Amendments to the Drawings:

REMARKS/ARGUMENTS

Appo. No. 09/776,067

Reply to Office Action of October 4, 2004
Annotated Sheet Showing Changes

FIG. 4

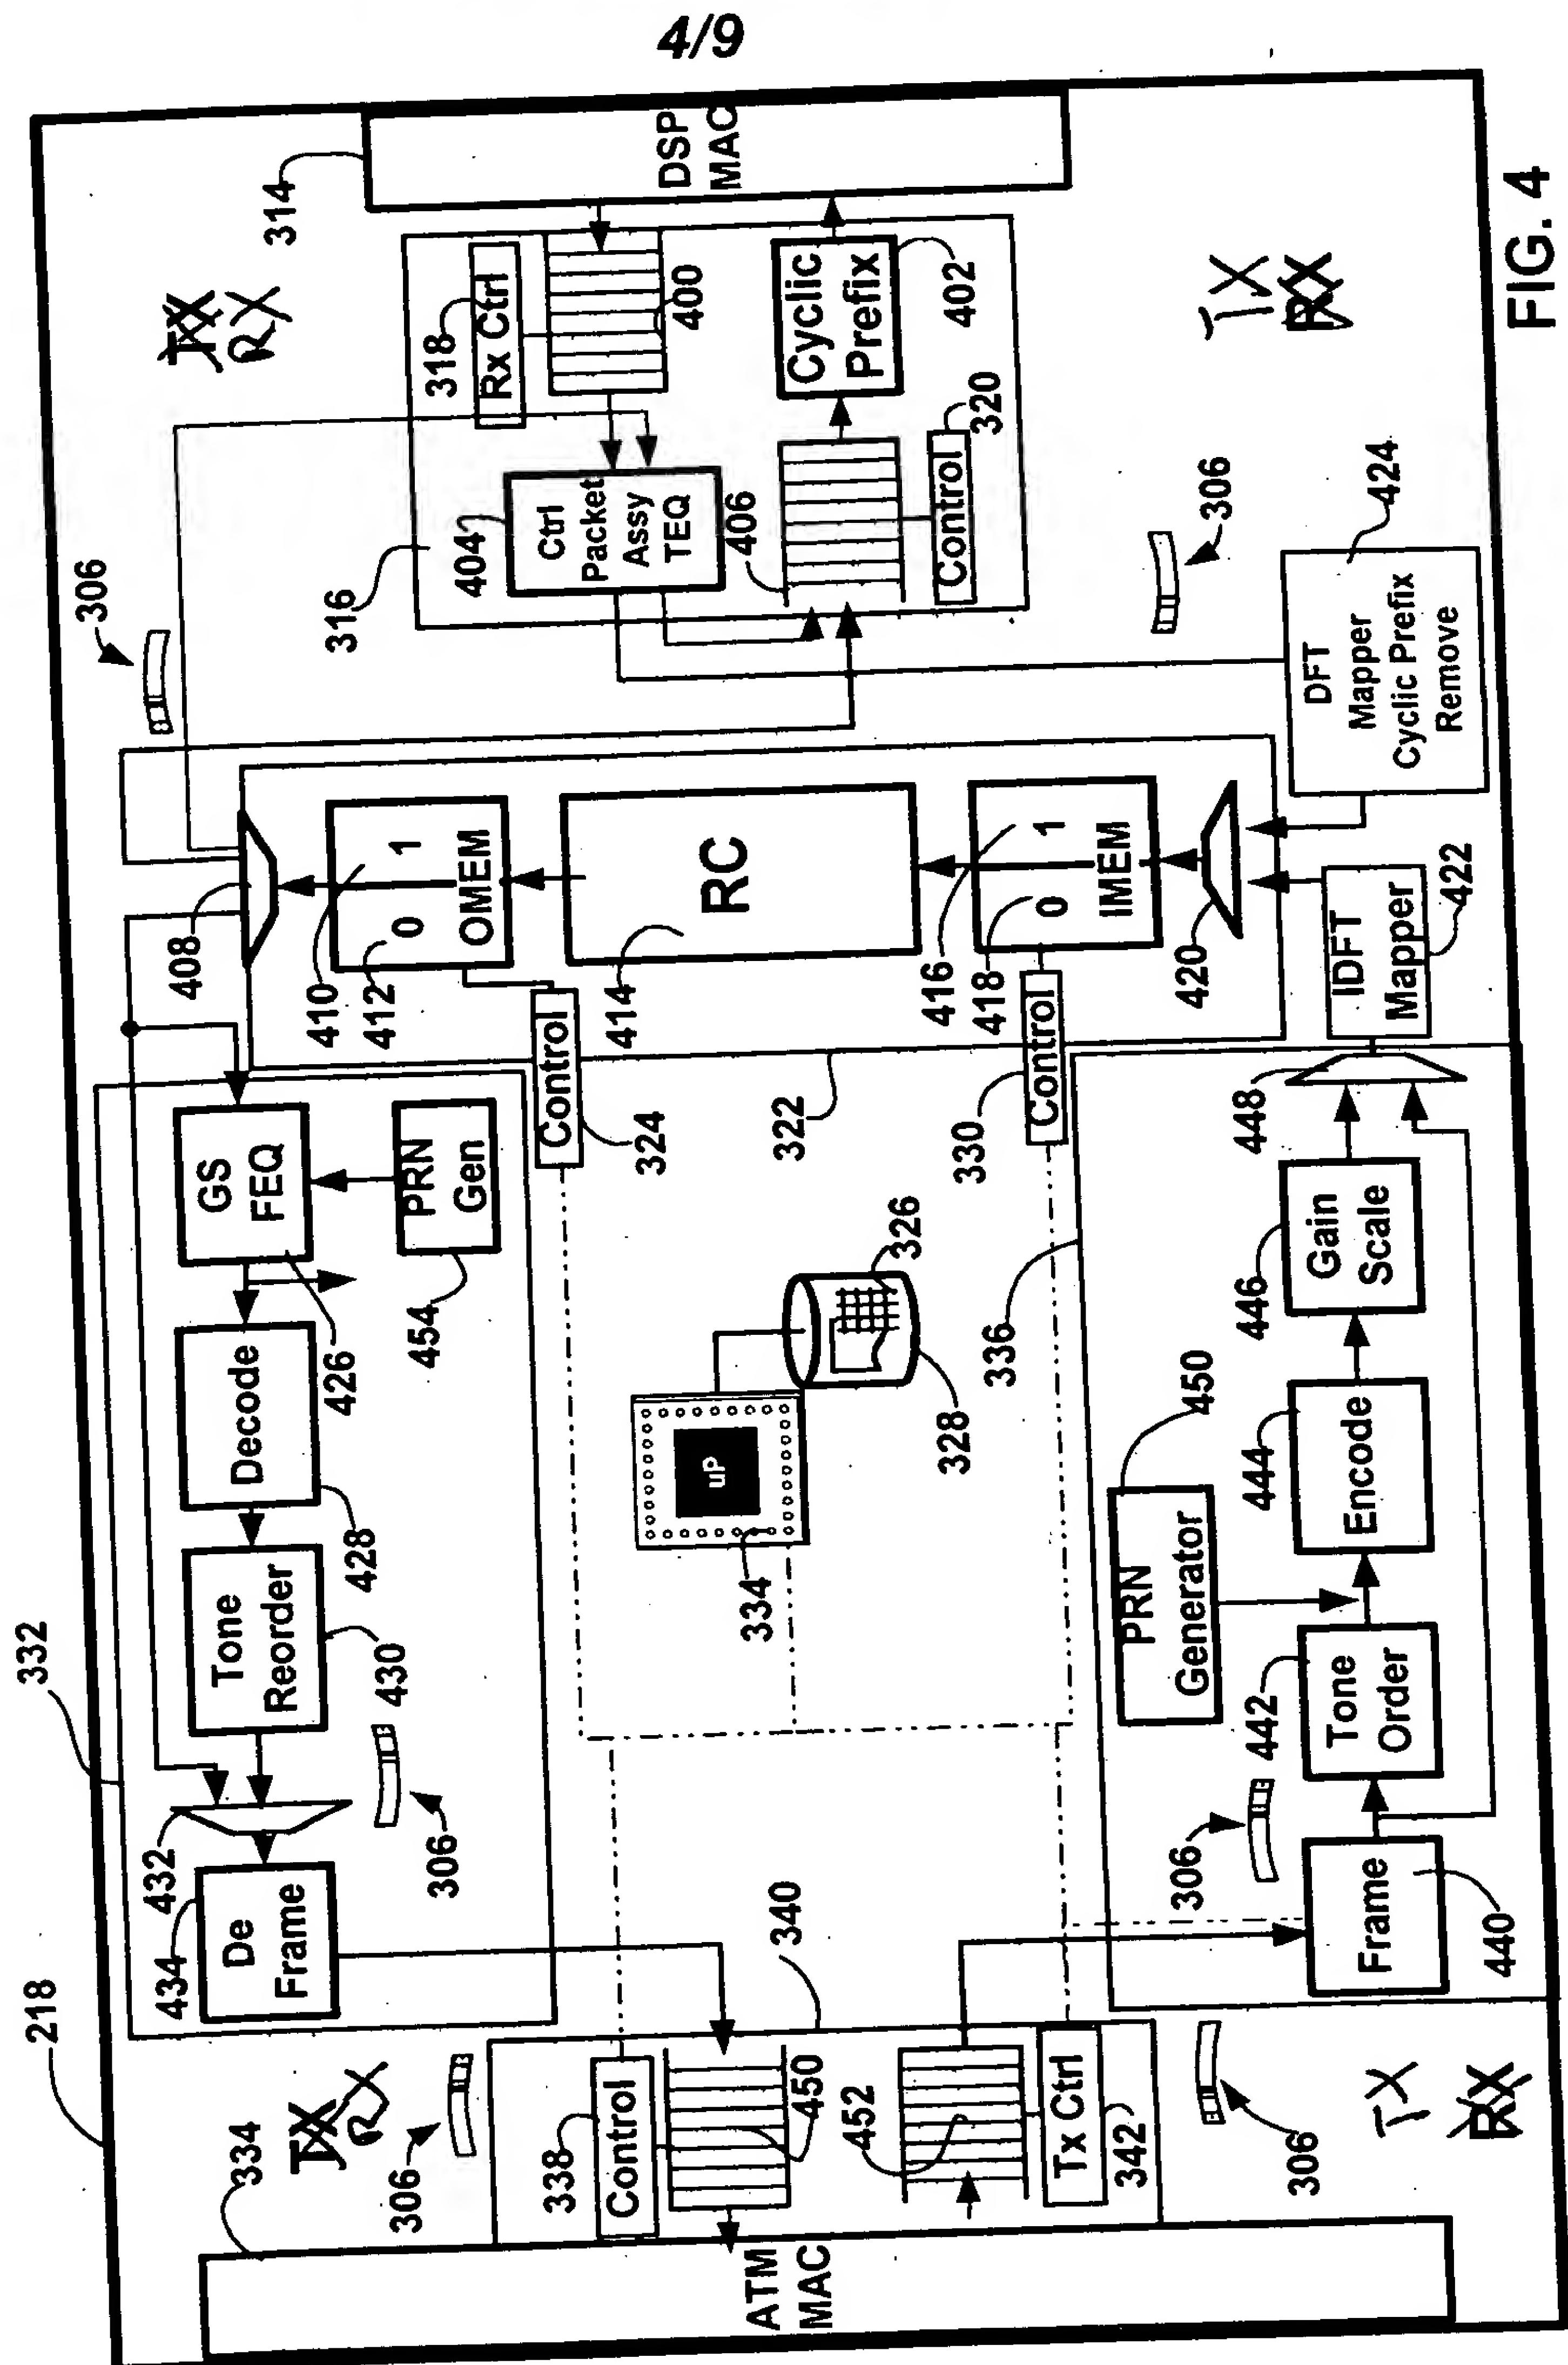
The Examiner objected to Figures 3 and 4 in which the “TX” and “RX” labels were reversed.

The Applicant has made correction to the above-mentioned figures as required.
